December 5, 2016
BOARD OF COUNTY COMMISSIONERS
ORANGE COUNTY, FLORIDA
Addendum No. 4, IFB Y17-718-CC
DEPUTY JONATHAN "SCOTT" PINE COMMUNITY PARK

This addendum is hereby incorporated into the bid documents of the project referenced above. The following items are clarifications, corrections, additions, deletions and/or revisions to, and shall take precedence over, the original documents. Underlining indicates additions, deletions are indicated by ~~strikethrough~~.

AS101

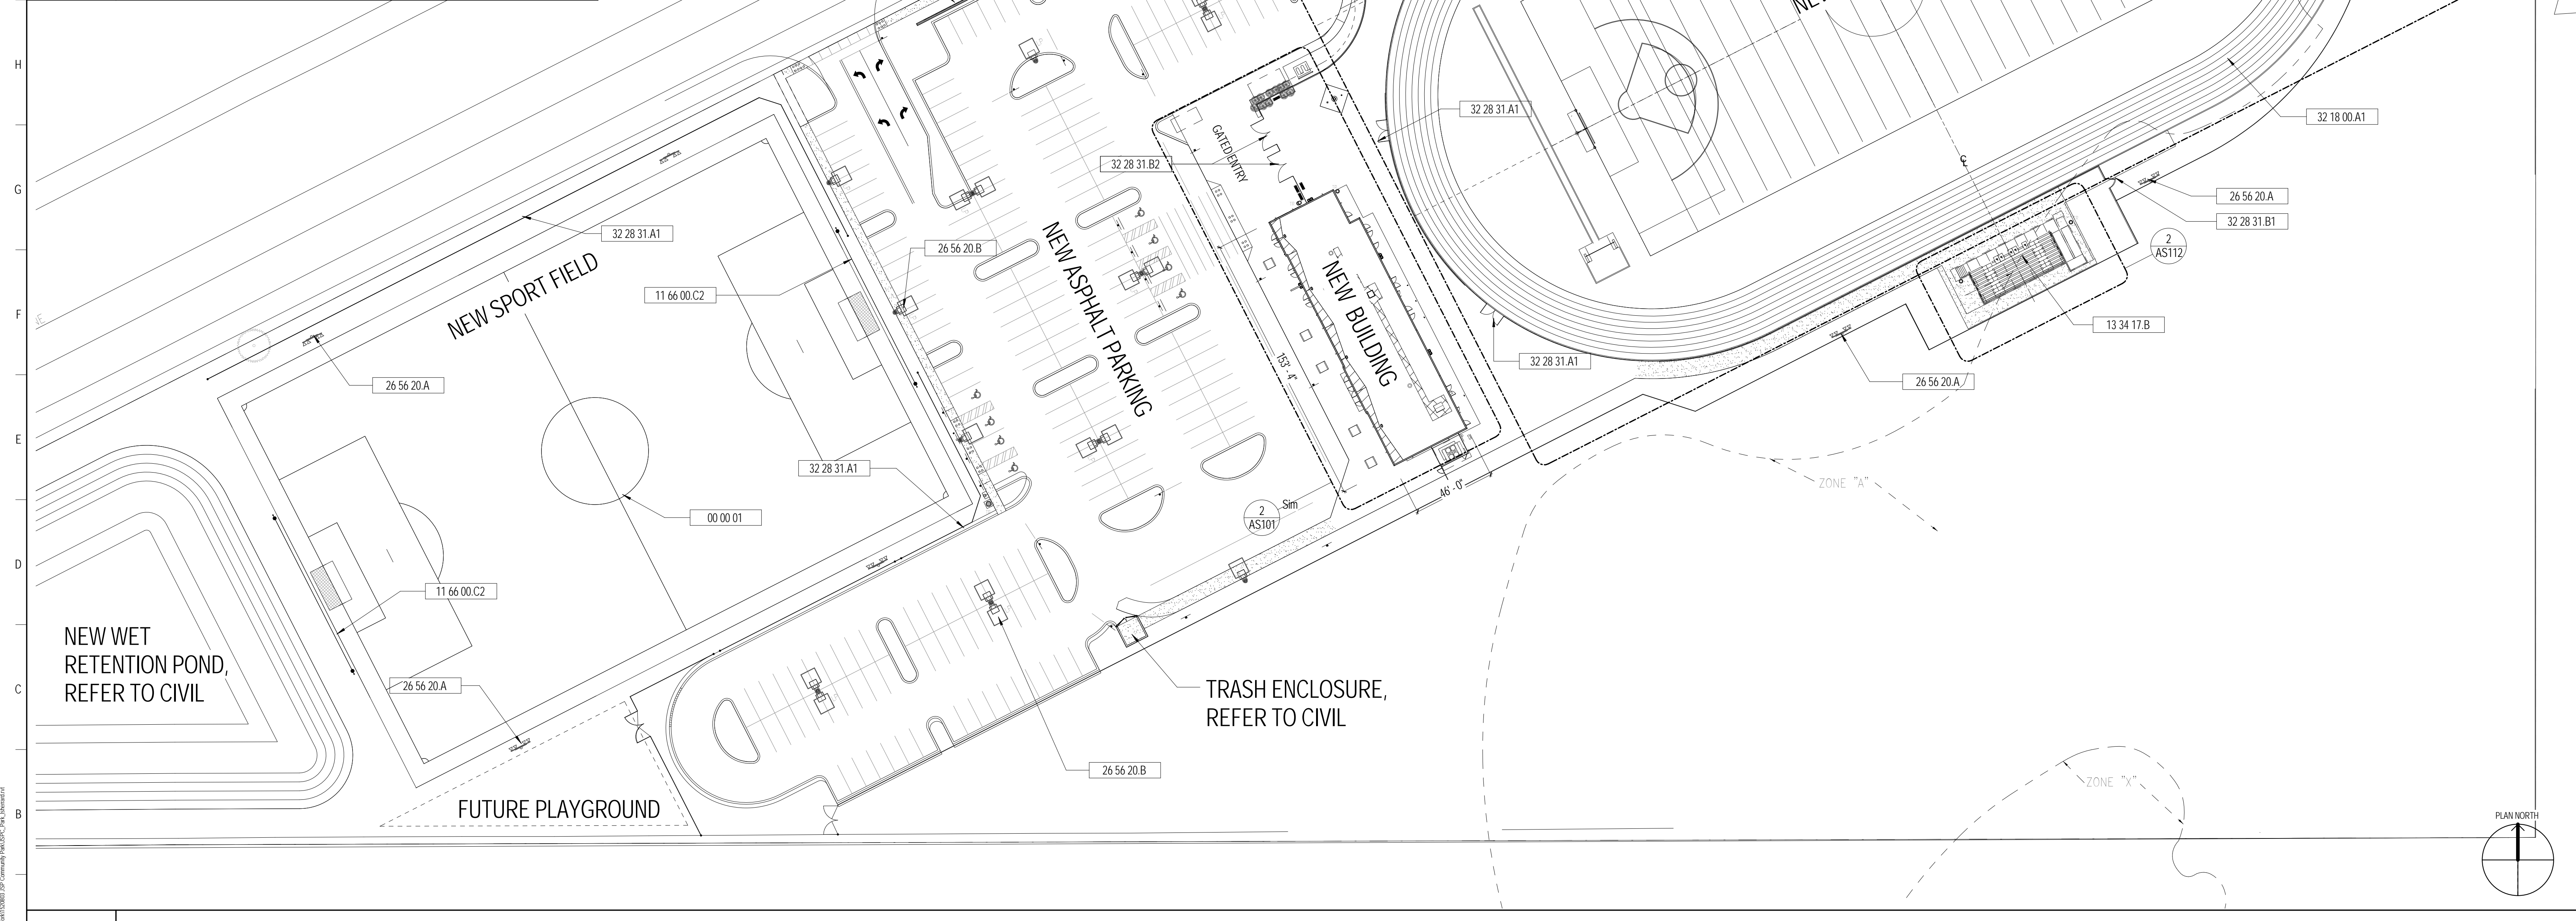
- i. New counter top section at ticket booth
 - d. DRAWING SHEET AS101 – ARCHITECTURAL SITE PLAN, dated 12/5/16
 - i. Revised Keynote 32 28 31.B2. Removed panic hardware note.

5. **Question:** Drawing AS101 indicates 2 double gates with Keynote 32 28 31.B2 16' Double Chain Link Gate, Match Fence Height, Provide Panic Egress Hardware, Refer to Civil for Additional Information. The Civil Drawings do not indicate and details for the Panic Egress Hardware. Please provide additional information and details for the 2 double gates with Panic Egress Hardware.

Answer: Egress Panic hardware requirement will be eliminated from the project. Refer to revised key note 32 28 31.B2 on AS101. Refer to spec section 31 28 31 section 2.4 for all other gate requirements.

9 COUNTER TOP SECTION @ TICKET BOOTH
1 1/2" = 1'-0"

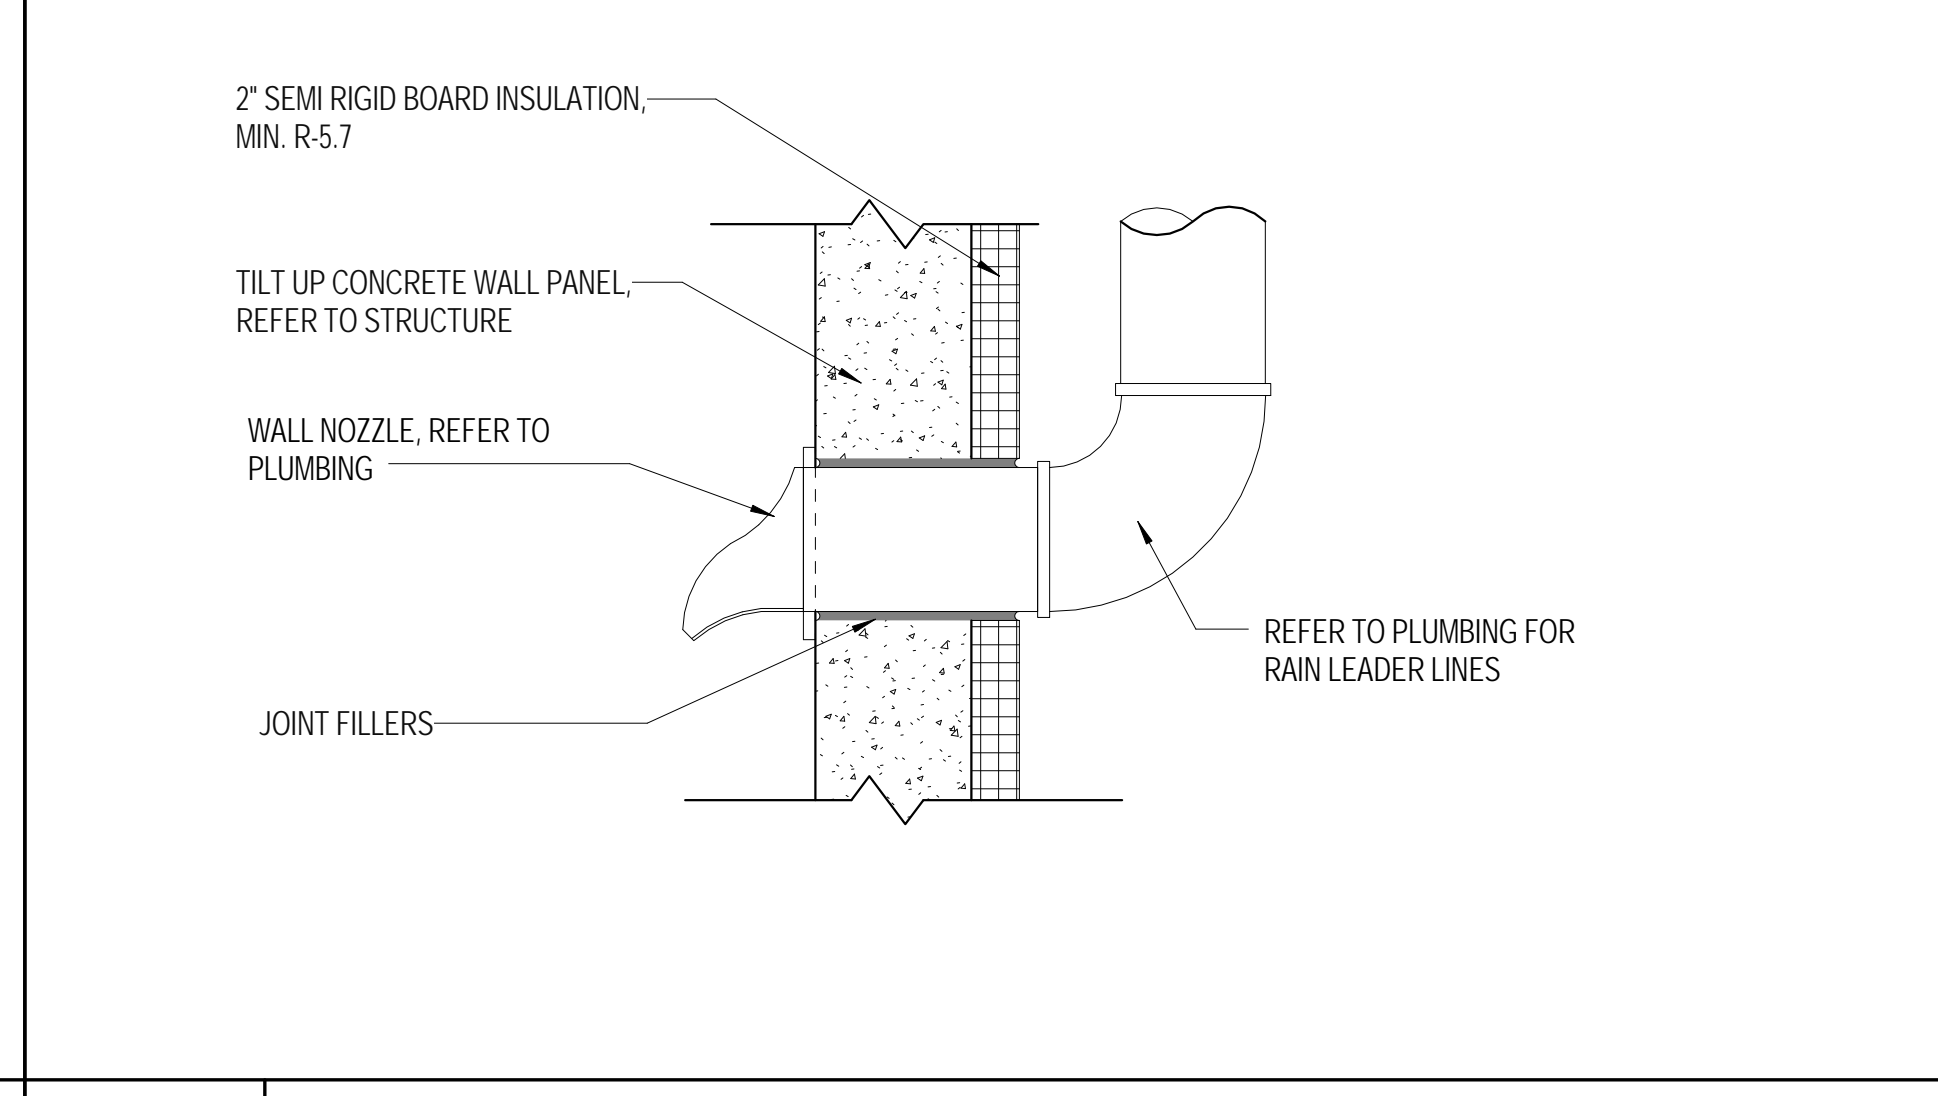
12. Question: Please indicate what the support structure is that will hold the Stainless Steel Counter Top indicated on Detail 3 on Drawing A101 as Specification 12 36 16.1 in the Ticket Booth. The Drawings and Specifications do not indicate any base cabinets and or counter top legs to support this Stainless Steel Counter Top. Should this Stainless Steel Counter Top indicated be a Stainless Steel Table Work Table, and if so, what size?

Answer: Supports to be per new detail 9/A901. Size support angles for counter depth as shown on plans. Also refer to response on Addendum #2, question 4 and refer to spec section 12 36 16 – Metal Countertops, shelving and tables, paragraphs 1.2-A.1, and 2.2-A.
